Subject: Arkansas Nuclear One – Units 1 and 2
Docket Nos. 50-313 and 50-368
License Nos. DPR-51 and NPF-6
Additional Information Regarding Condensate Storage Tank Volume
Technical Specification Changes (TAC NOS. MA8206 and MA8207)

Response to NRC RAIs on ANO CST License Amendment Request

FIGURE 1 – ANO-1 EMERGENCY FEEDWATER SYSTEM

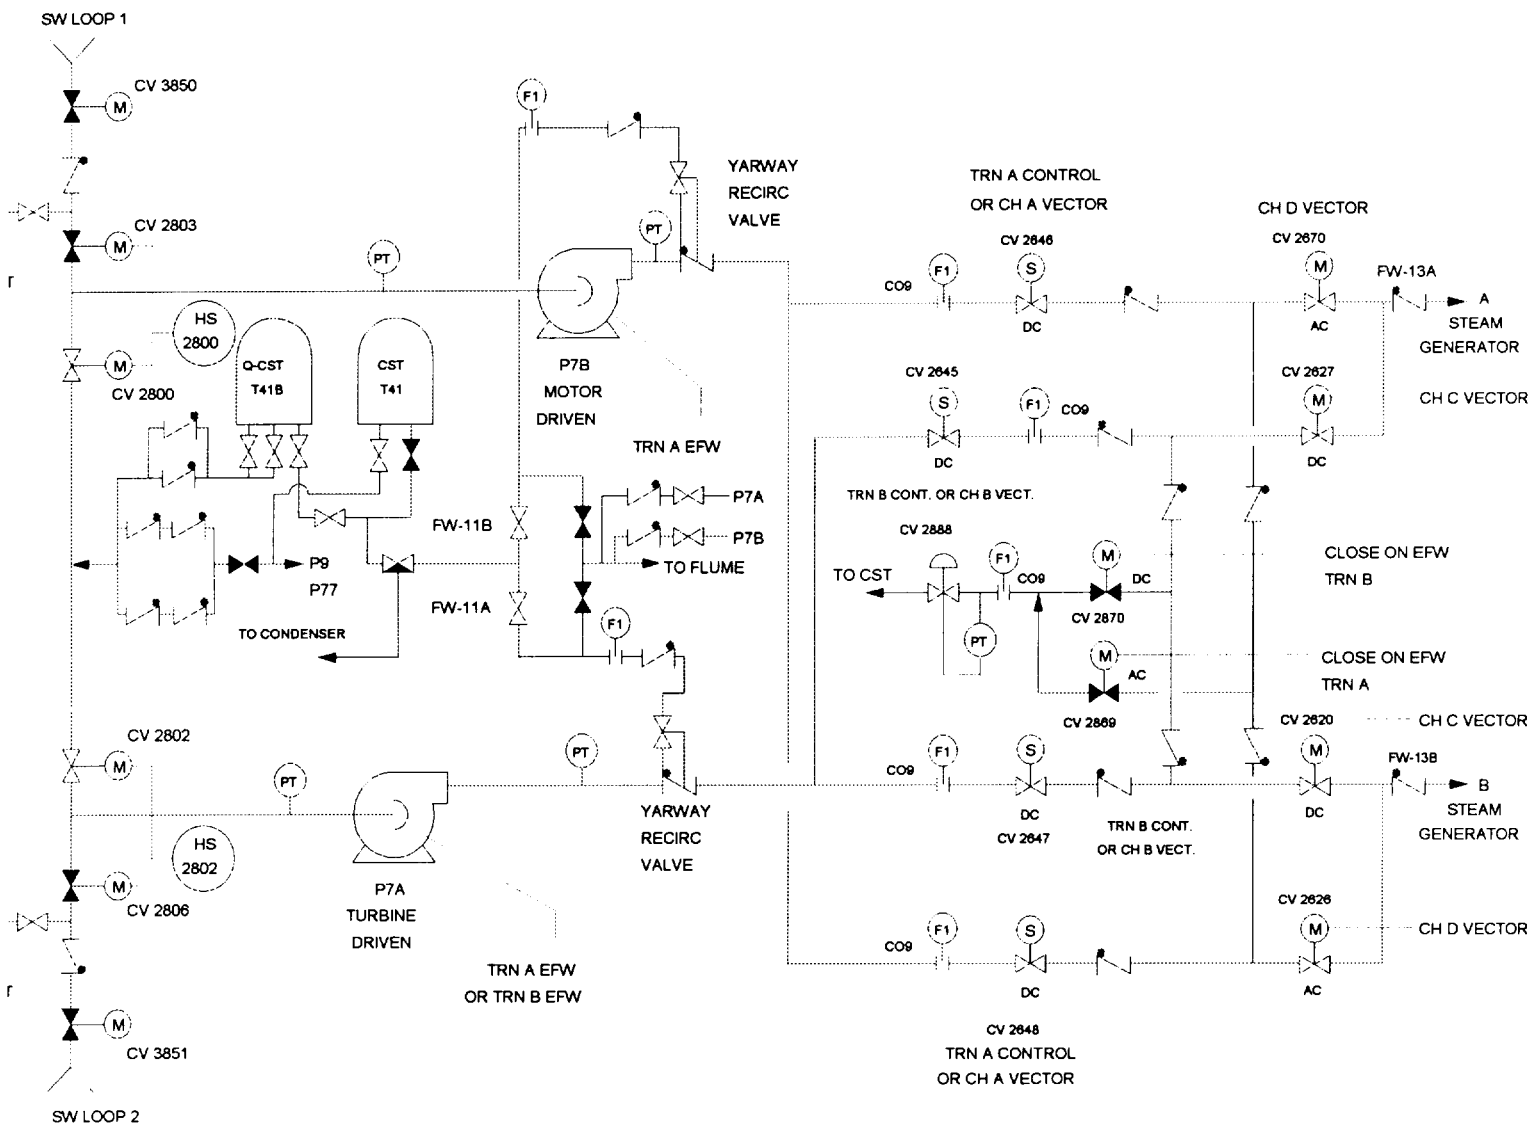
How is the flow path from the service water system to the EFW systems tested or inspected to demonstrate that they are free of blockages or silting? Are the valves needed to realign the source of auxiliary feedwater systems to the service water systems tested to demonstrate that they will be capable of performing their intended function? How often are they tested? Does the proposed TS change require changes in your inservice testing program or otherwise require additional equipment to be tested?

Are the valves needed to realign the source of auxiliary feedwater systems to the service water systems tested to demonstrate that they will be capable of performing their intended function? How often are they tested?

Water from either CST is aligned to the suction of each pump through an 8" motor operated gate valve. Water supply to P-7A is isolated by CV-2802 while CV-2800 isolates water to P-7B. These isolation valves are located in the EFW pump room and are normally open. These valves are stroked closed and open each quarter using Supplement 3, Emergency Feedwater Valve Stroke Testing, of 1106.006.

SW loop 2 supplies P-7A through motor operated valve (MOV) CV-3851 and suction supply isolation CV-2806. SW Loop 1 supplies P-7B through motor operated isolation valve CV-3850 and suction supply isolation CV-2803. SW loop and suction supply isolations to EFW are normally closed. These valves are stroked open each quarter using instructions contained in Supplement 3 of 1106.006.

Figure 1 shows that closure of CV-2802 and opening of CV-2806 and CV-3851 will align service water to P-7A. To align service water to P-7B, CV-2800 is closed and CV-3850 and CV-2803 are opened. No other valve manipulations are required.

FIGURE 2 - ANO-2 EFW/AFW One Line Diagram

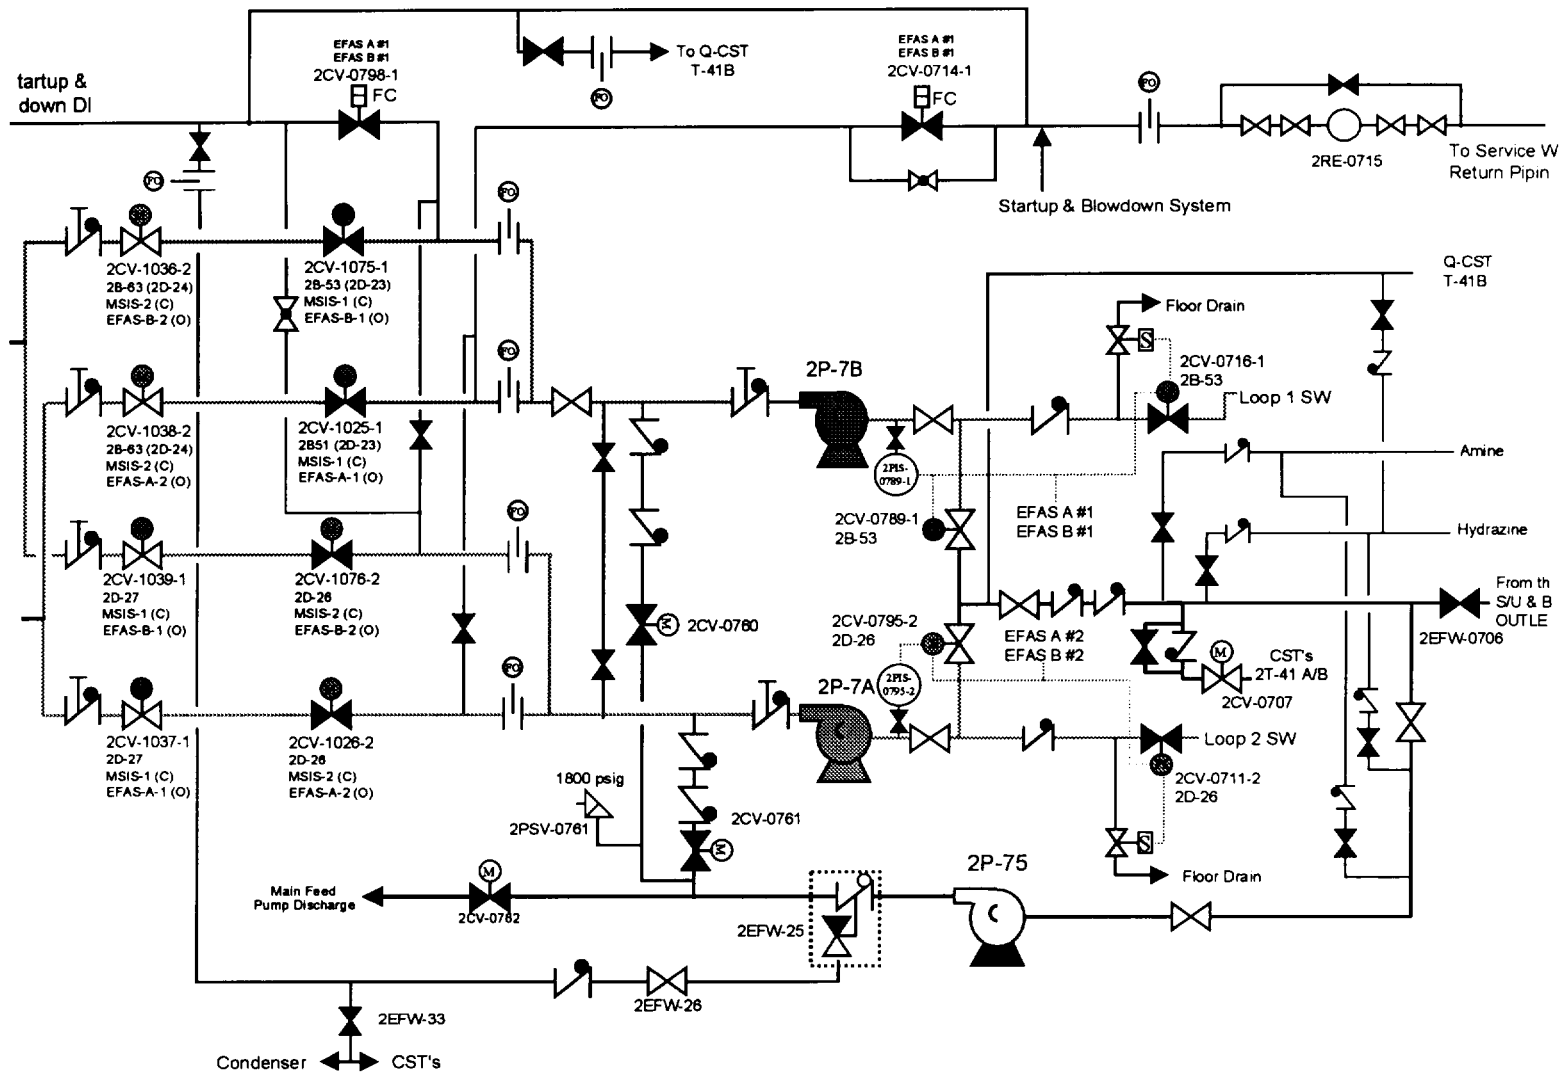
Are the valves needed to realign the source of auxiliary feedwater systems to the service water systems tested to demonstrate that they will be capable of performing their intended function? How often are they tested?

As the attached ANO-2 emergency feedwater simplified system drawing (Figure 2) reflects, opening 2CV-0716-1 and 2CV-0711-2 will align service water to the suction of the EFW pumps and closure of two MOVs (2CV-0798-1 and 2CV-0795-2) will isolate suction from either the QCST (T-41B) or the ANO-2 CSTs (2T-41A or 2T-41B). The hand switches for these valves are located on panels in the Unit 2 control room. These valves are stroke tested quarterly using instructions contained in Supplement 3, Quarterly Emergency Feedwater Valve Stroke Testing. 2CV-0716-1 and 2CV-0711-2 are stroked open and 2CV-0798-1 and 2CV-0795-2 are stroked in the open and closed directions.
